Product/Process Change Notice (PCN)

PCN #: WE_LAN_20170705

Product Affected: WE-LAN

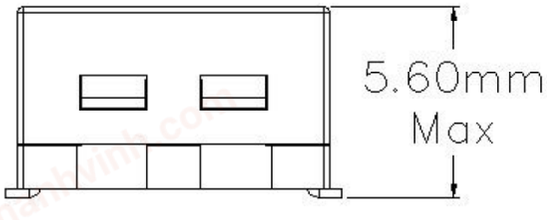
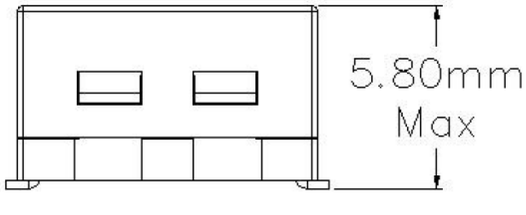
Due to a database mismatch, Würth Elektronik will update the height of following parts: 7490100111B, 7490120110 and S16100110.

As the existing header can meet the requirement of “5,60mm max” height, the datasheet will be updated.
